Memo

Re: PP-001108-2019: Canyon Creek Filing No. 7 & 8 Preliminary Plat Application

Responses by Henry Design Group and CWC 7-21-2020

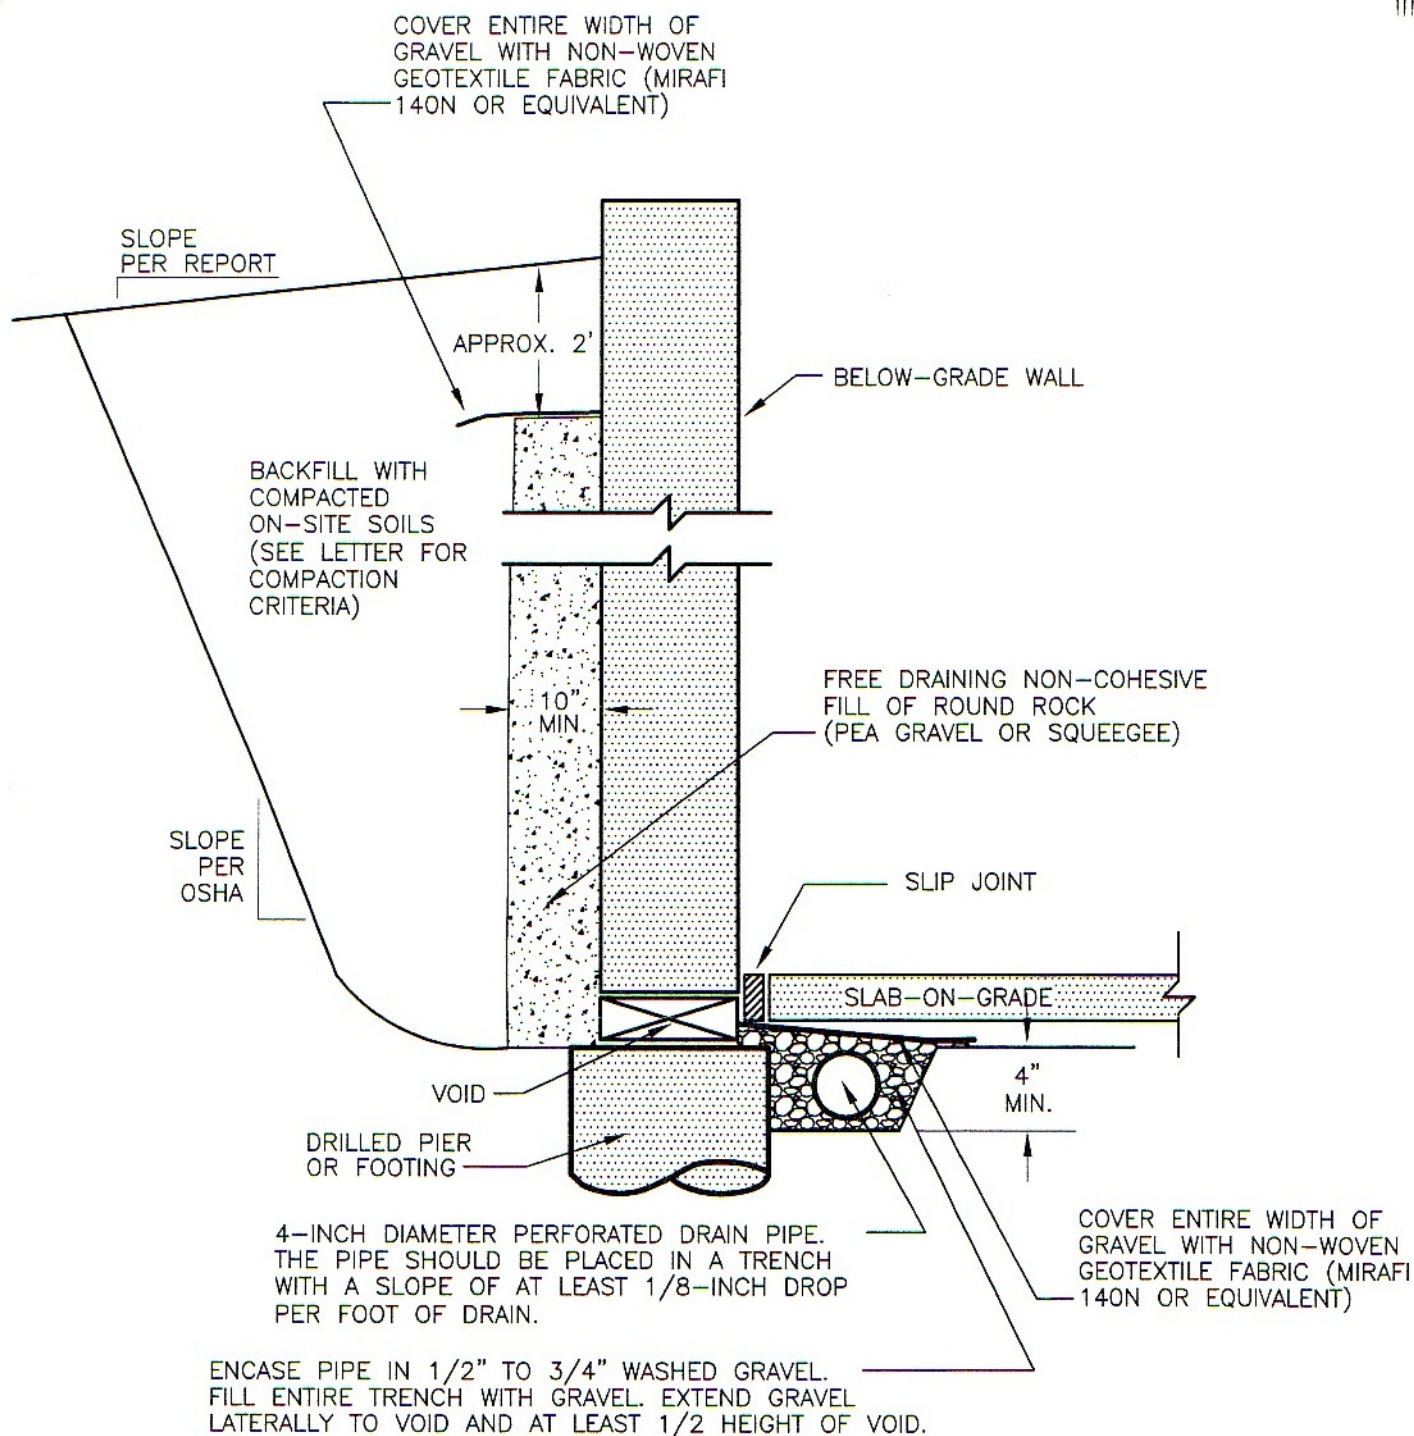
However, research performed by Western Environment has been unable to confirm the location or existence of the Standard Mine shaft referenced above. This included review of the "Standard, Star and Jackson Mines" map dated 1888. It is our opinion that this document is uniquely inaccurate with the lack of any verifiable or reliable survey monuments that could indicate that a mine shaft is located in the vicinity of Filing 7. Therefore, Western Environment choose to use the CGS 1989 Mining and Surface Features Boulder-Weld Coal Field Map. This map is reproduced on Figure 2 of the July 8th, 2020 report. Furthermore, the results of the borings completed by Western Environment tend to confirm, at least in general, this depiction.

Therefore, based upon these inherent inaccuracies, all reported shaft locations within Subsidence Zone B occur within Open Space. However, due to the concerns expressed by the CGS in their July 27th, 2020 memo, **Western Environment agrees with the CGS that a "qualified inspector" be present during all over-lot grading activities within Filing 7, Track C, Blocks 1 and 8 to identify unmapped shafts.**

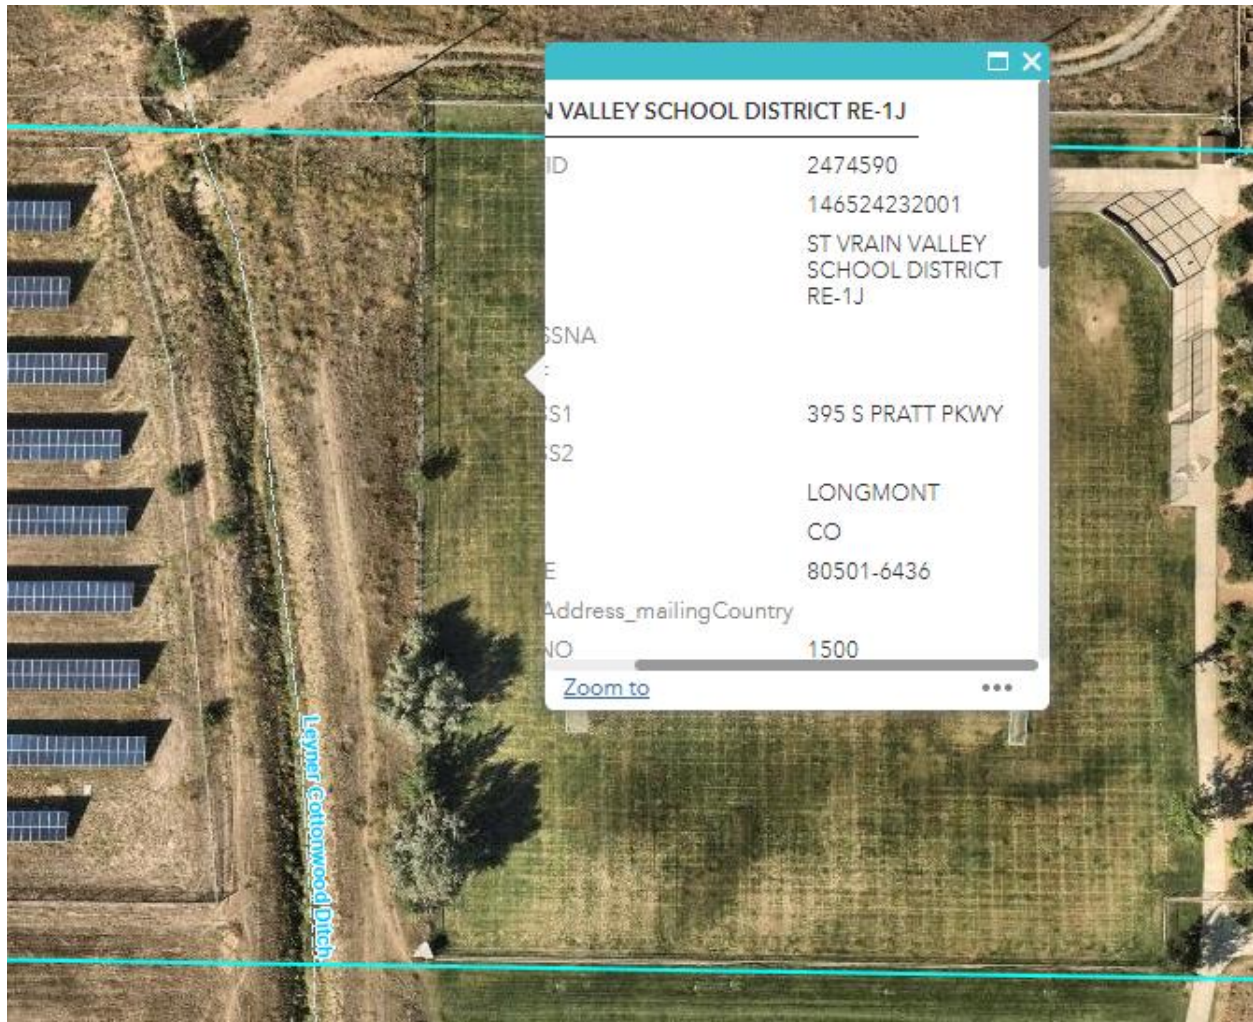
Is the Town Property referenced the Leyner Cottonwood Ditch easement? The 30-foot proposed utility easement for the water line goes beyond what appears to be the ditch easement boundary. Clarify this on Sheets 26 and 27. Also, the Leyner Cottonwood Ditch agreement shall address having the water line within the ditch easement. See below.

RESPONSE4: the easement is a proposed 30' wide utility easement and is proposed to be located within the Town of Erie property not the school's property.
